Cleveland City Planning Commission

October 17, 2025

AGENDA

Proposed Site Plan Scale: 1" = 60'-0"

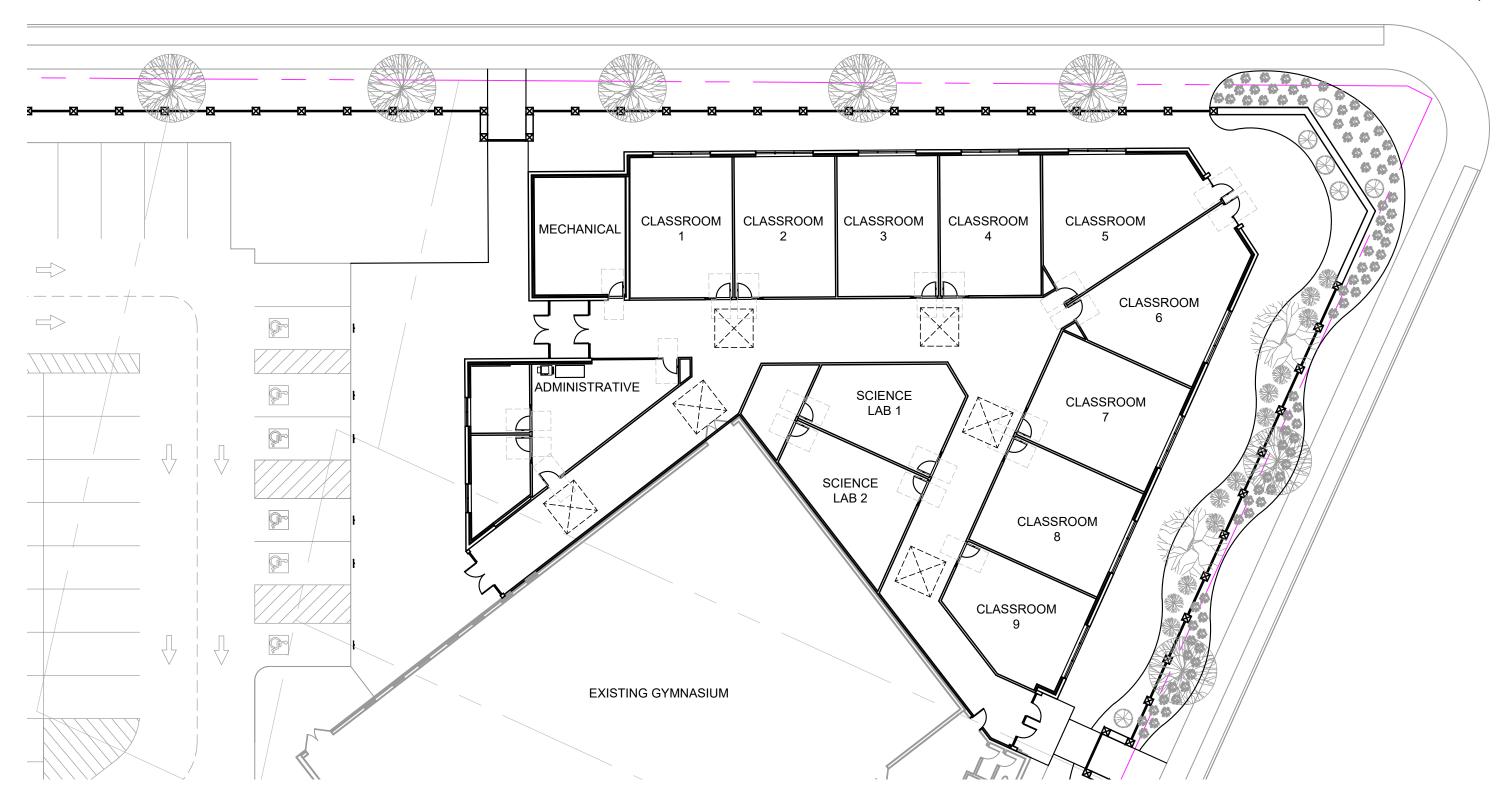
- Provide additional information and drawing on parking lot configuration, including proposed lighting and landscaping islands
- Study alternative facade materials and additional articulation of facade
- Provide parapet / elevation section to ensure proper screening
- Further development of Rocky River Dr "entry/exit" point

What We Heard

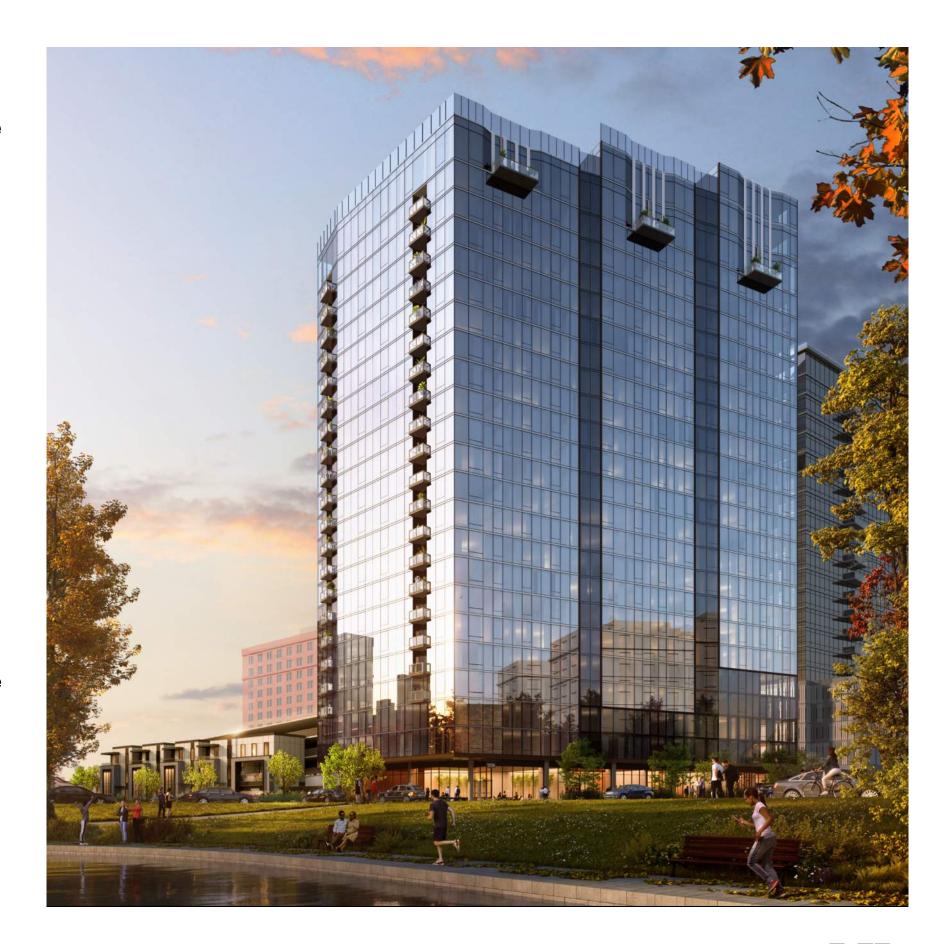
- **Phasing** Return with Phasing Strategy showing architecture and landscape of each phase: how site is treated before townhouse construction. (will garage be exposed, any upturned beams; how adjacent site (south) will be treated in phasing.

- **Connection to Townhome**s Study how the base of the building may be tied in to the townhomes, whether materials can be incorporated into building from the pedestrian level.

- **Spandrel Glass** provide a clearer idea of how this will in the daytime with materiality using close up rendering of balcony and building and provide a night view showing vertical striping of spandrel verses daylit interiors

- Large Concrete wall at the Garage on the South how will it be treated? Is there an opportunity at the base for art as screening? Show interim treatment(s) between phases

- Complete Landscape & Lighting Plans, detailed retail space treatment

RELOCATED PARKING

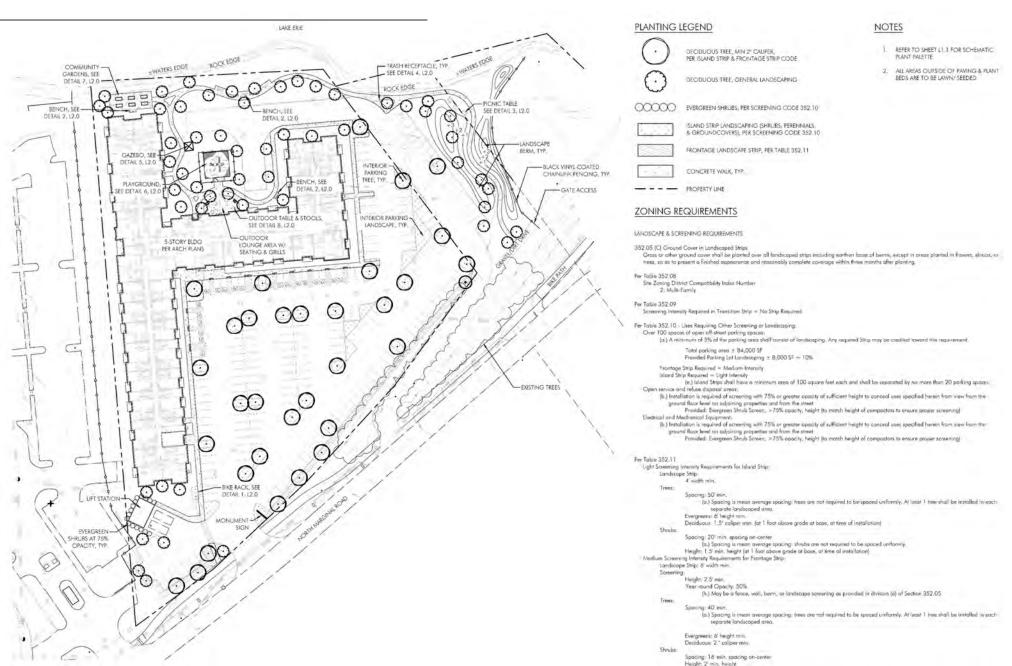
- 1. STUDY RTA CONNECTIVITY FURTHER AND SEE IF A BUS STOP CAN BE RELOCATED: CURRENTLY UNDER REVIEW AND AWAITING UPDATES FROM THE DIRECTOR OF CITY PLANNING.
- 2. REVIEW THE AMOUNT OF AMENITIES ON SITE TO SEE IF MORE CAN BE ADDED: NEW AMENITIES INCLUDE PET WASH STATIONS, COMMUNITY GARDENS, A MULTI-USE LAWN, GAZEBO, EXTERIOR BIKE PARKING, AND CONTINUOUS WALKING PATH AROUND THE BUILDING.
- 3. LOOK INTO RELOCATING THE 17 PARKING SPACES NORTH OF THE SITE:
 ALL 17 PARKING SPACES NORTH OF THE SITE HAVE BEEN RELOCATED BY DISTRIBUTING
 SPACES TO THE AGREED UPON EASEMENT AND REWORKING SOME PARKING TO THE
 SOUTH.

SHIFTED ALL PARKING FROM THE NORTH END OF THE BUILDING TO THE EAST AND SOUTH

REVIEWED CITY VACATED RIGHT OF WAY ALLOWED USES AND ADDED CITY PARK TO THE EAST SIDE OF SITE. REMOVED PARKING FROM EAST HALF OF THE VACATED RIGHT OF WAY PER CURRENT LEASE WITH PROPERTY OWNER AND PER CITY REAL ESTATE DEPARTMENT.

Limit driveway dimensions to 20'

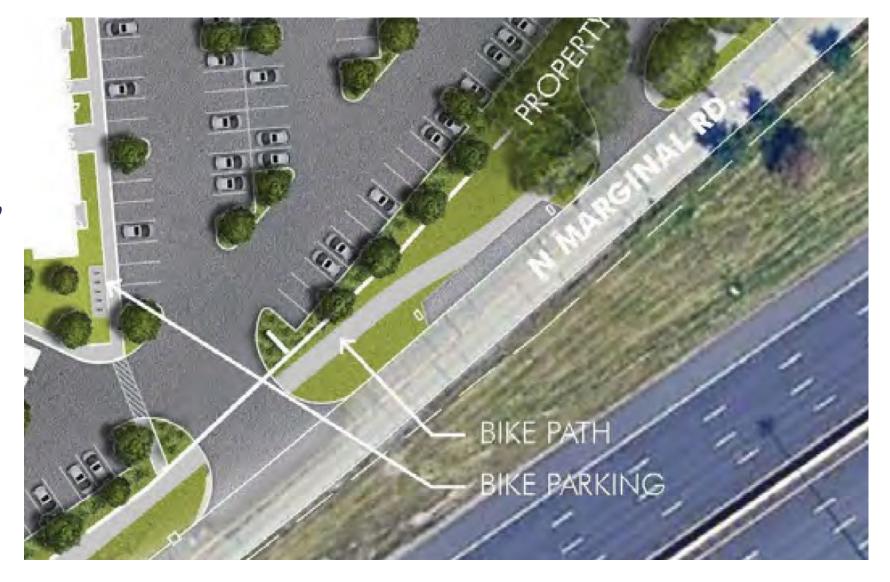
Driveway exceeds code maximum of 30'
